The City of Spartanburg Design Review Board

AGENDA

- 1. DRB-24-020-00017 – The Design Review Board (DRB) has received a request for Full and Final Approval for the proposed building, Danbury Commons, located at 203 Fremont Avenue (Tax Map Sheet: 7-12-01-080.00) with a zoning designation of DT-4 Zone (Downtown Urban District). **Owner: Dialysis Clinic Inc / Agent: Connelly Development, LLC.**

- 2. DRB-24-020-00018 – The Design Review Board (DRB) has received a request for Full & Final Approval for the proposed Building, Grain District Office, located at 245 W Main Street (Tax Map Sheet: 7-12-14-005.00) with a zoning designation of DT-5 Zone (Downtown Urban District) **Owner: Morgan & Henry JOF ESA LLC / Applicant: McMillan Pazdan Smith Architecture.**

Initial Proposal - Streetscape Width

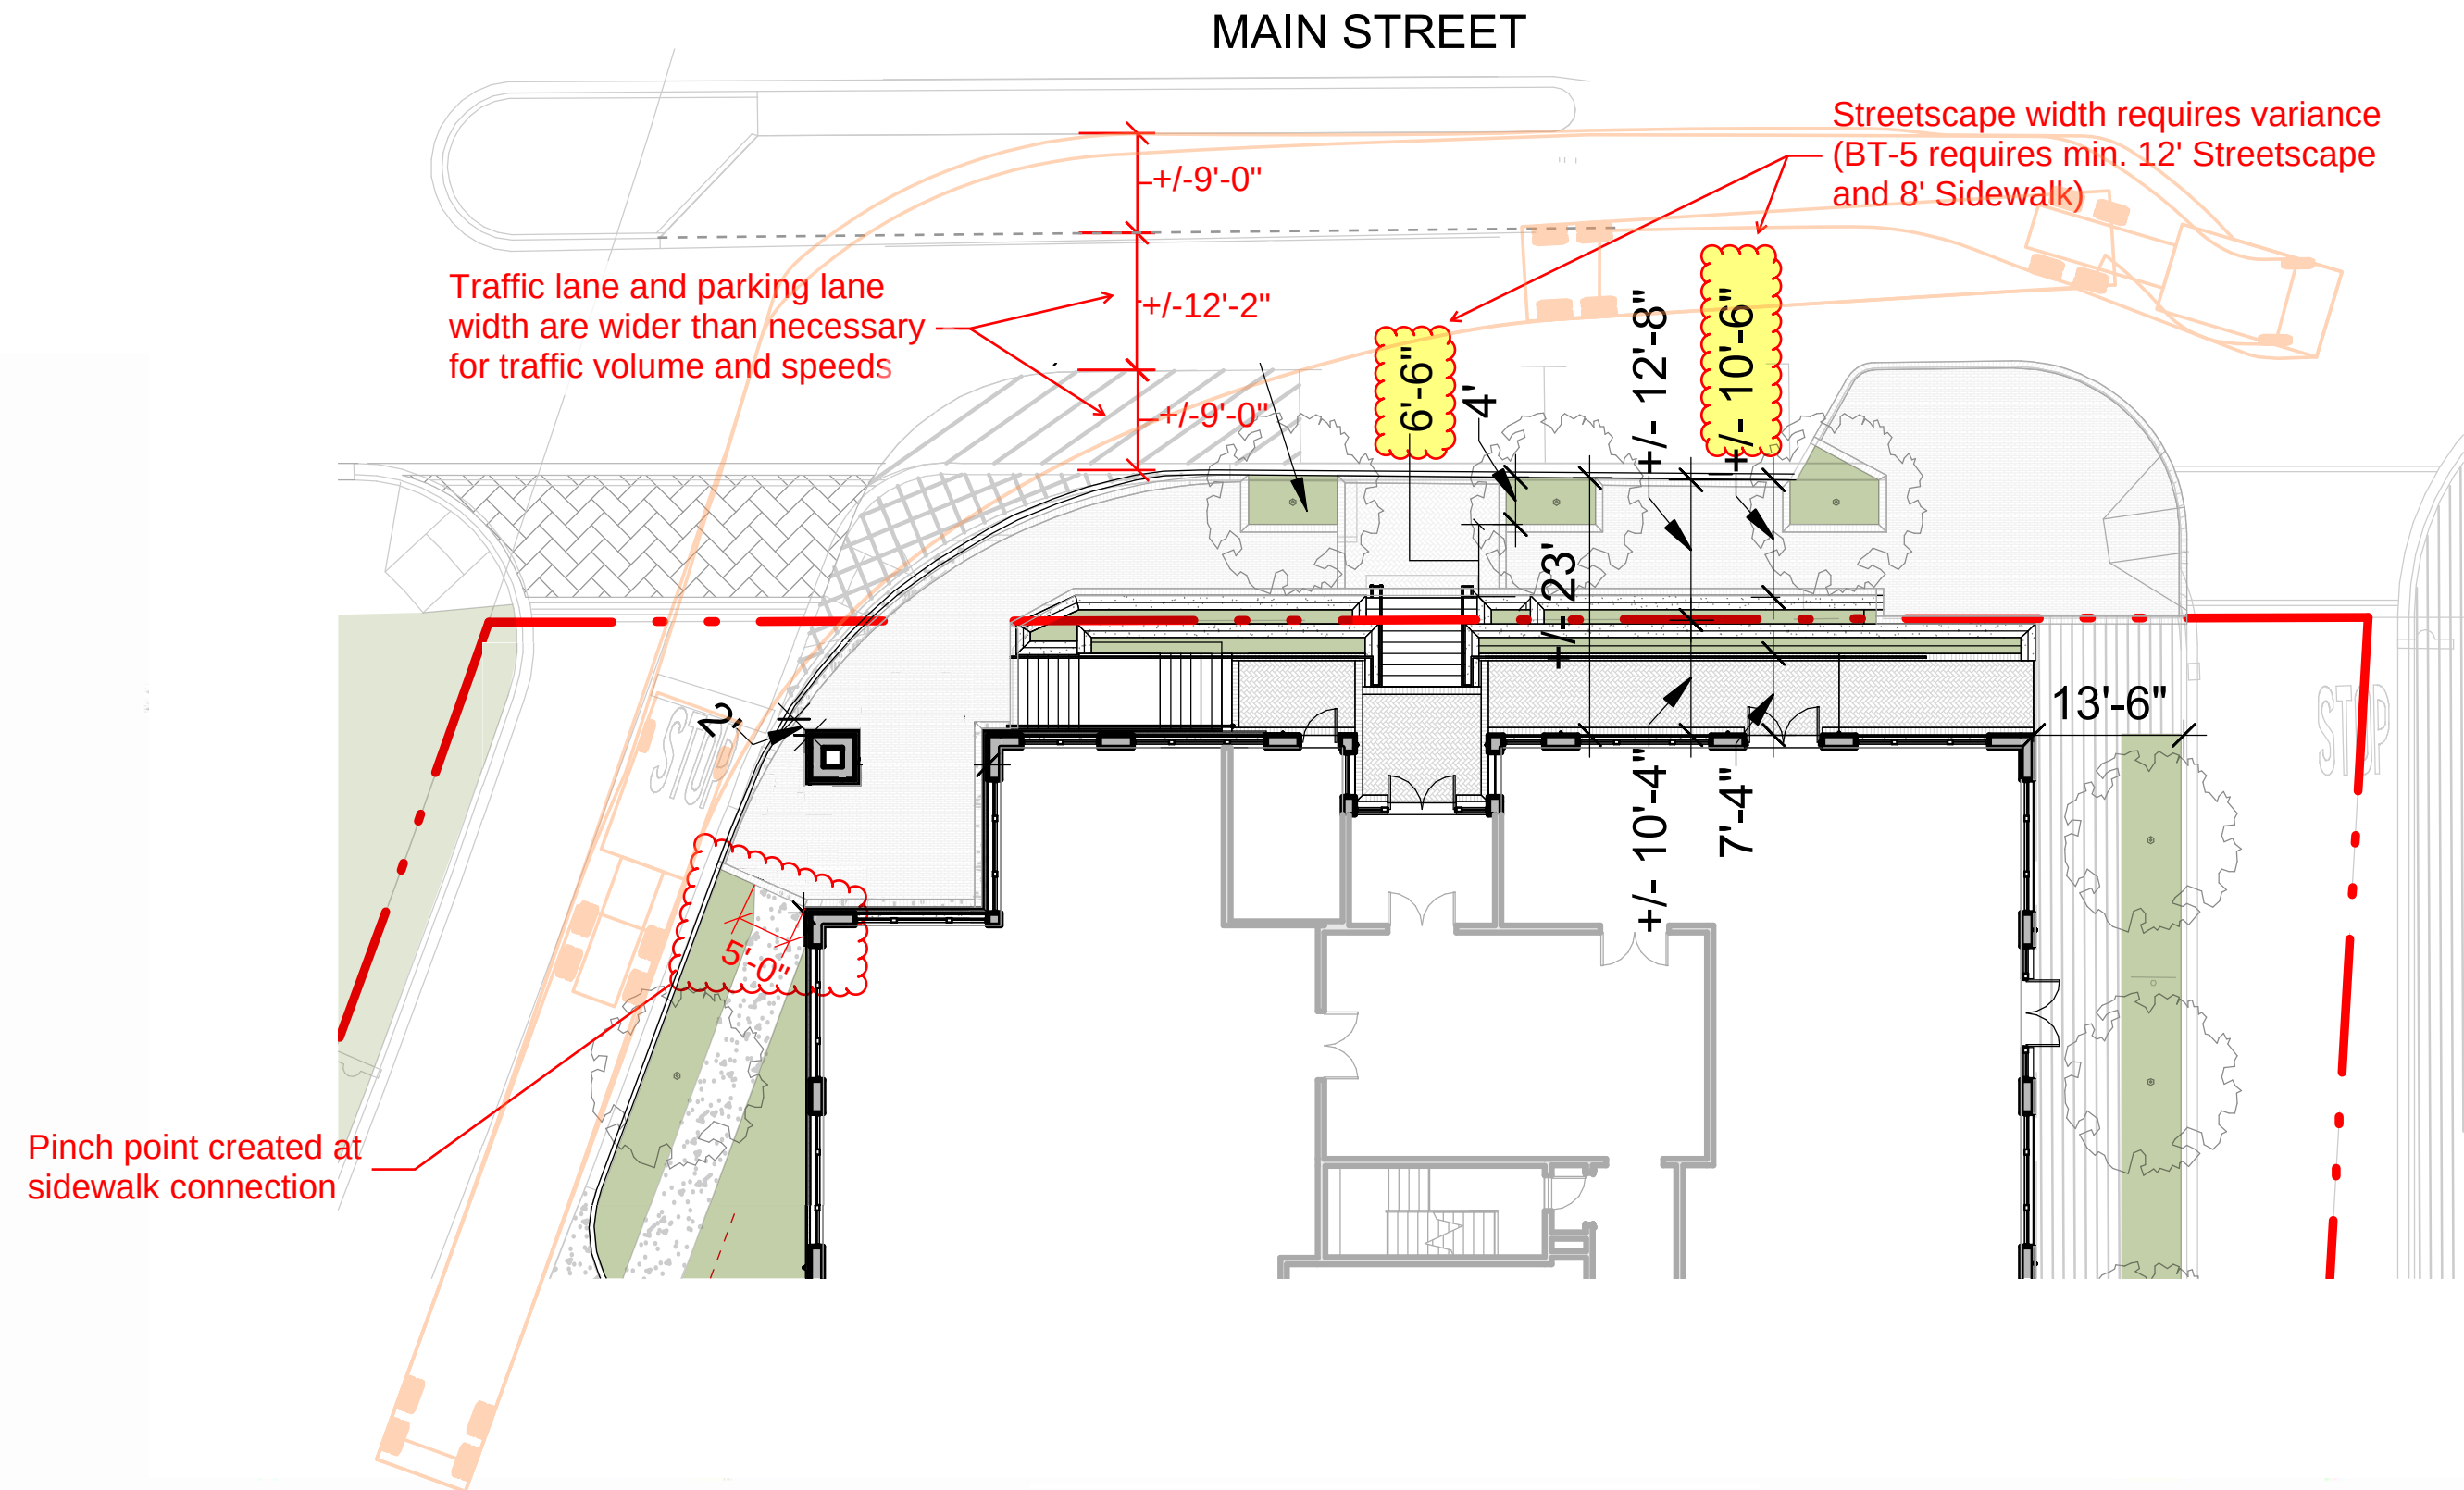
3) Streetscape Width

DT-5 requires a 12'-0" wide streetscape along street frontages. The Grain District Office Building complies with the required width, except for a 21 square foot area as shown, which reduces the streetscape down to 8'-1" at the narrowest point.

Traffic lane and parking lane width reduced yet maintain appropriate dimension for anticipated volume and speeds.

Streetscape conforms to DT-5 requirements.

Arcade Treatment

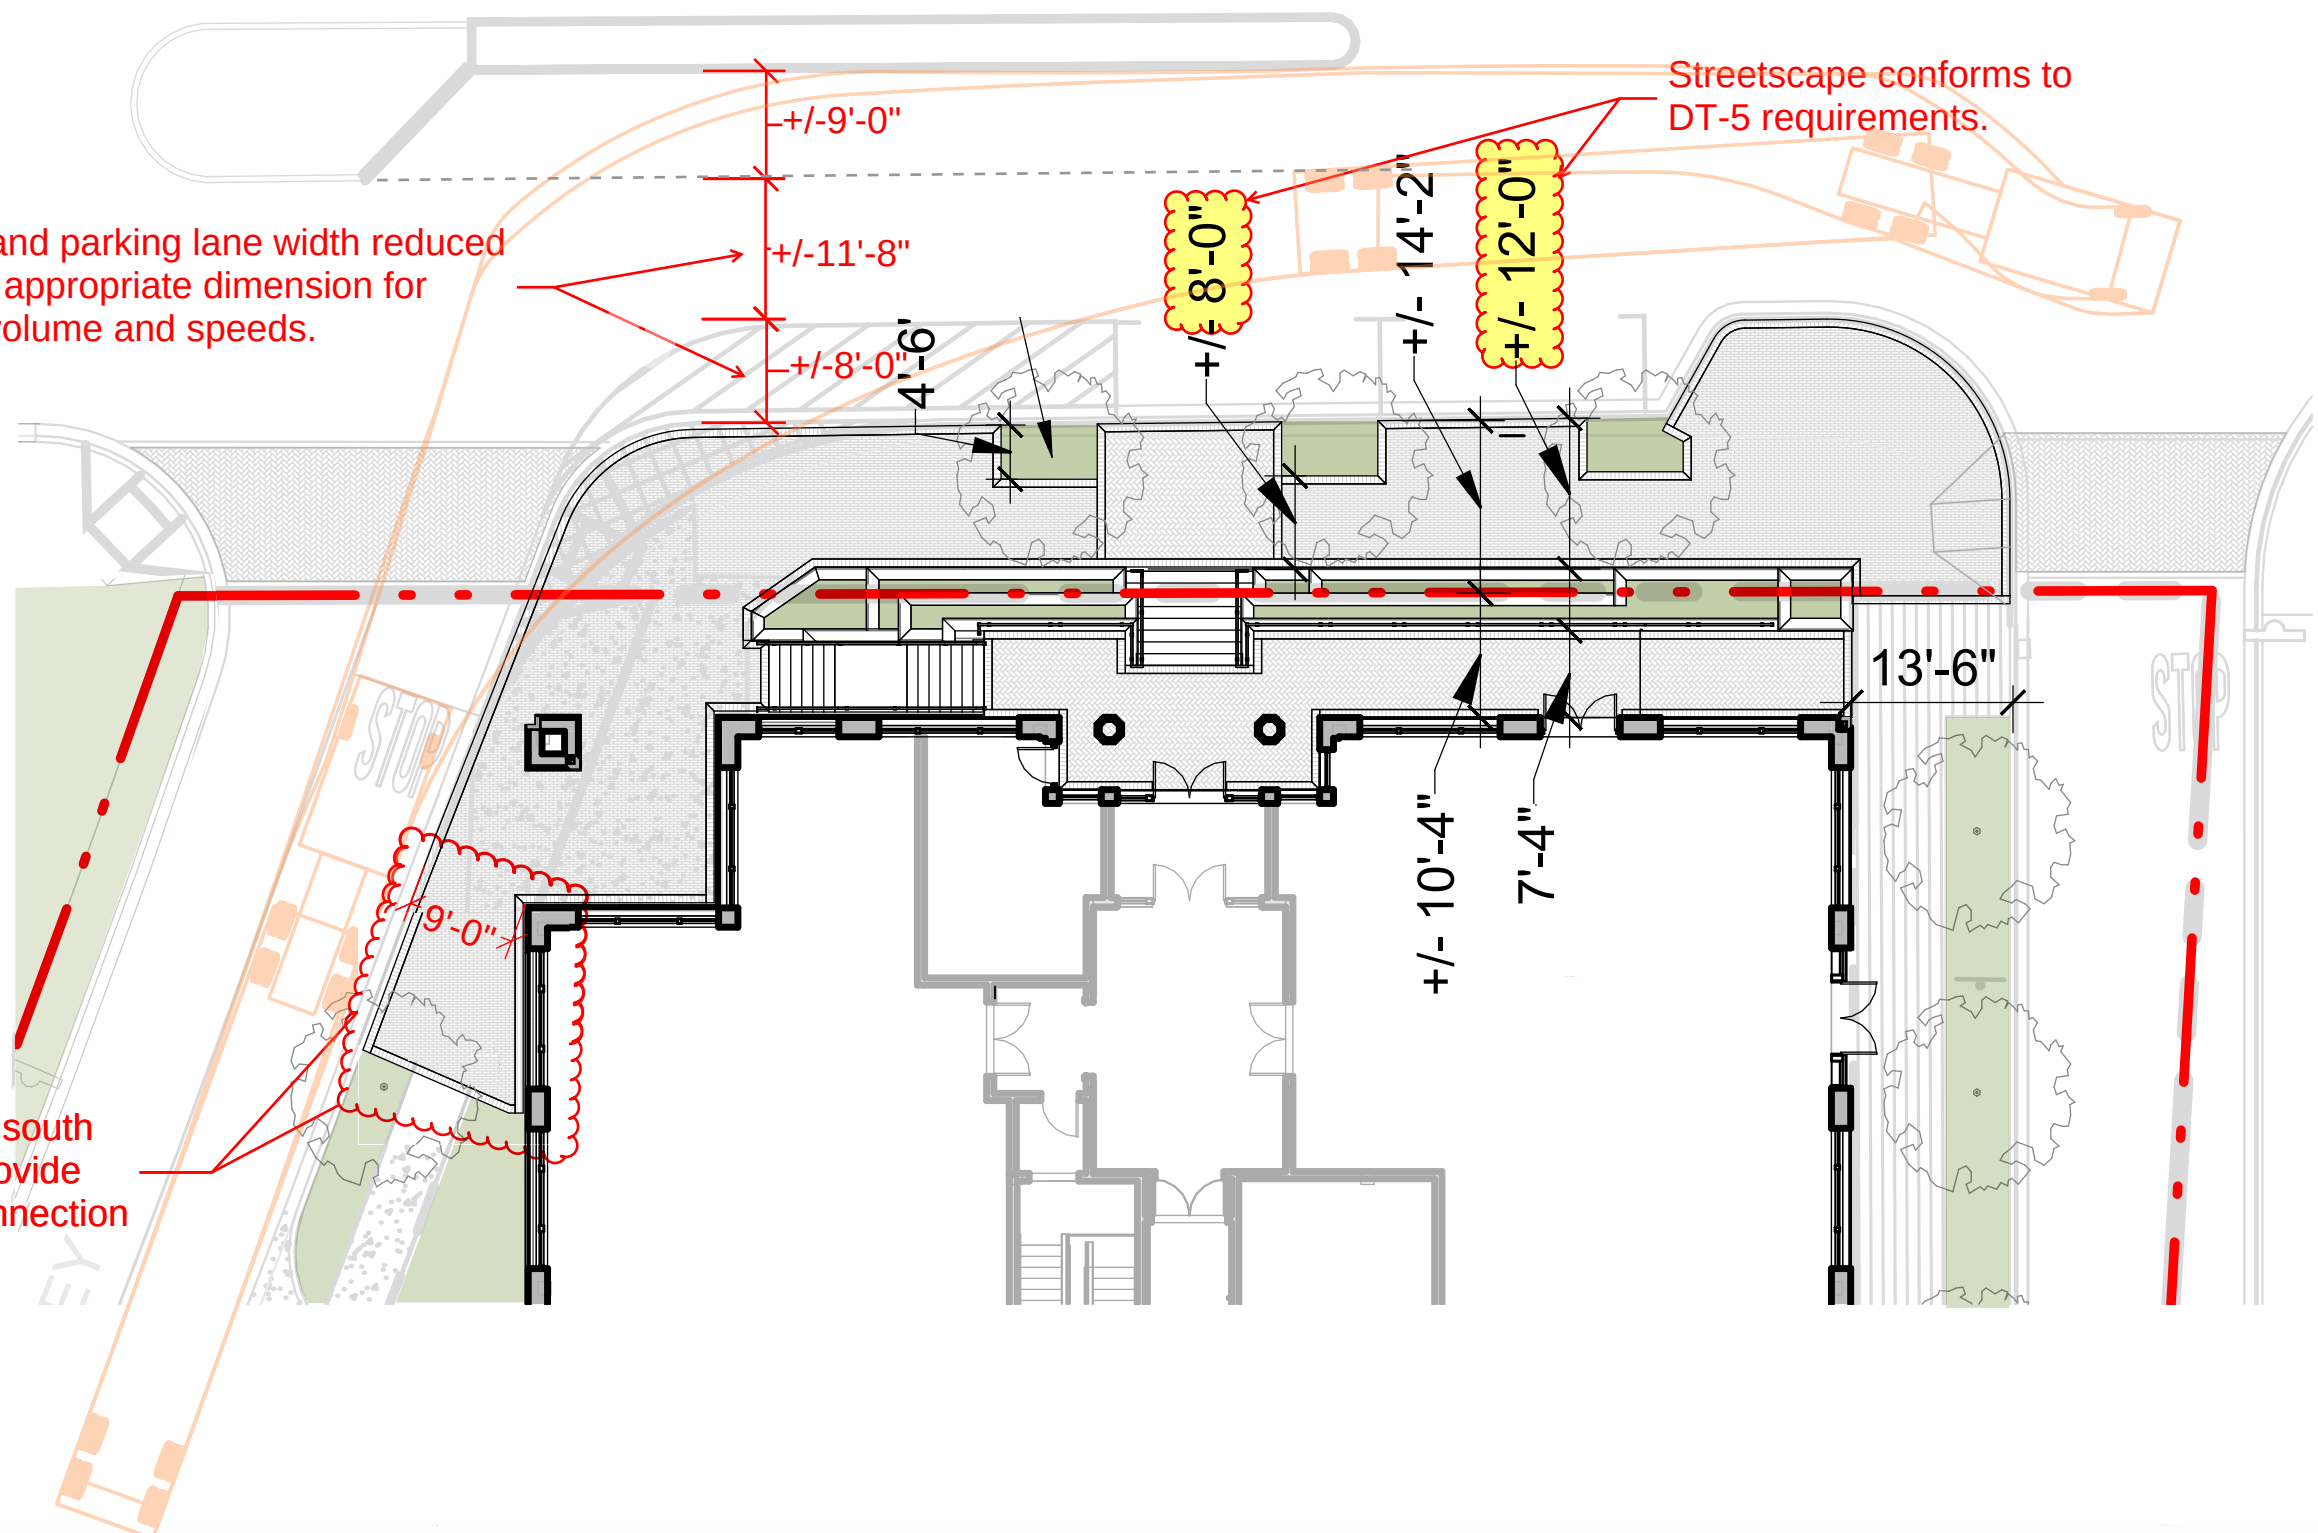
Arcade Treatment: The proposed “arcade” encroachment in the right-of-way for Batter’s Alley is a unique condition that seems to be a hybrid of the historic and practical use of the treatment. The typical arcade does in fact provide additional “air rights” encroachment to permit more building mass than a site would otherwise allow if restricted to a property boundary. Similarly, historic arcades also provided some element of ground floor retail or building entries.

The proposed treatment appears to simply provide the air-rights for the expansion of the building footprint with no ground floor amenity to offset the encroachment. *Lighting has been added as well as some form of an inset panel. Without active space in or near that area (e.g., windows, doors, or some type of interactive elements), staff’s opinion is that the arcade will feel blank and barren.*

- Revisit the continuous route along Batter's Alley and the sidewalk condition at the arcade.
- Provide lighting element details for the arcade to ensure proper lighting and public safety.
- Acknowledgement that unrestricted access along Batter's Alley and the arcade is required. The proposed "arcade" creates a unique right-of-way condition for Batter's Alley. The arcade will require a permanent pedestrian easement (or similar document) by the applicant to provide City and the general public unrestricted access.

Paver area extended south on Batters Alley to provide widened sidewalk connection
